Delegated Report

Planning Application No: 20231049

Location: Cherry Dene, Norwood Lane, Meopham, Gravesend DA13 0YE

Description: Erection of two detached houses with associated car parking, cart lodge car port and new entrance drive.

Drawing ADP23/P102/02 Site Layout. Current application 20231049.

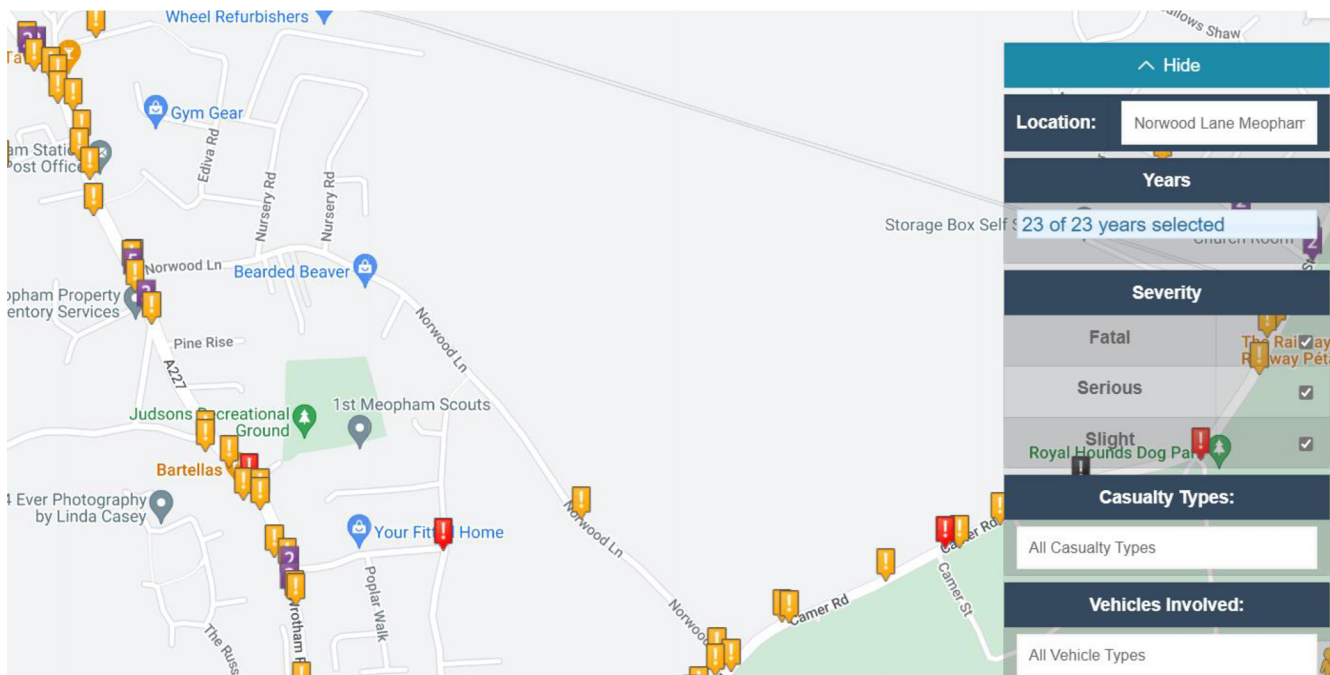
(A) Pre-advice for sight lines *Item 5. On comments given against application PRE20230098 Sight lines should be 43m x 2.4m x 43m at any new access and shown on a suitable drawing. This is appropriate for the 30mph speed limit Norwood Lane is subject to in this section of road.*

This compares to sight lines shown on the drawing of 43m x 2m x 43m

However, despite what may exist elsewhere in the road, it does not mean the situation should be compounded by permitting a substandard access. It should also be noted that even if the 2 metre 'X' distance was considered acceptable, this would create a blind spot in which cyclists could be hidden to the detriment of highway safety.

It is therefore considered appropriate that sight lines of 43m x 2.4m x 43m should be provided in the interests of road safety at any new access.

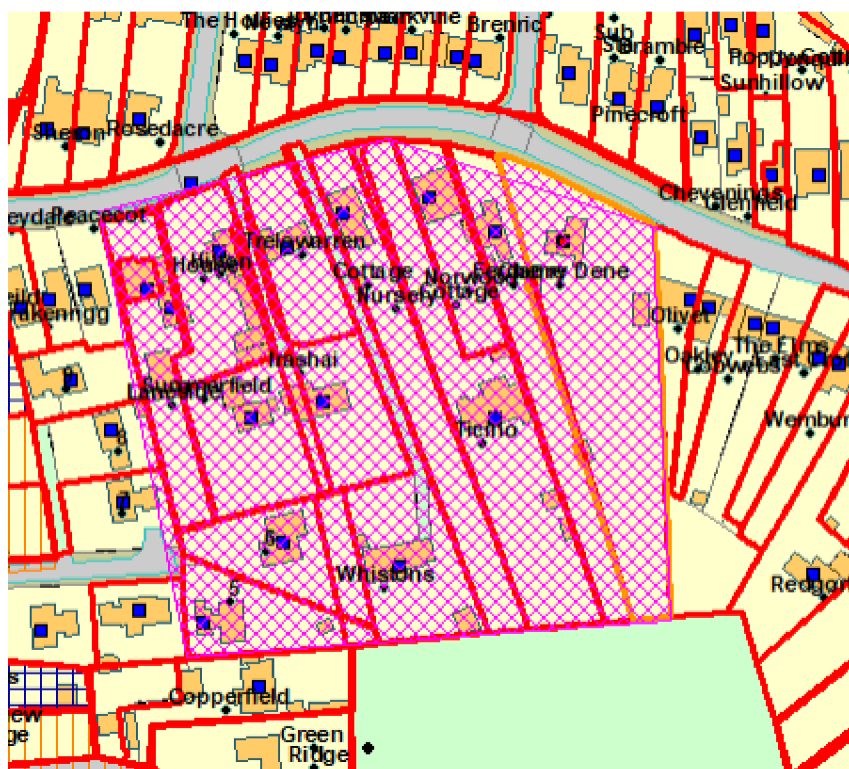
CD01 – house to the front of the plot	CD02 – rear most house

House CS01 is the northern most house and measures approx. 9.2m in height, 7.7m in width and 9.8m in depth. The internal floor area of approx. 134sqm. It has a rear garden of approx. 10m.

House CD02 is located to the rear (south) of the site. This property will be approx. 11m wide, 9.7m high and 9.5m deep with an internal floor area of approx. 204sqm. It will have a rear garden with a depth of approx. 12m.

Both properties are served by a carport measuring approx. 6.8m wide, 6.1m deep and 5.5m high with a pitched roof.
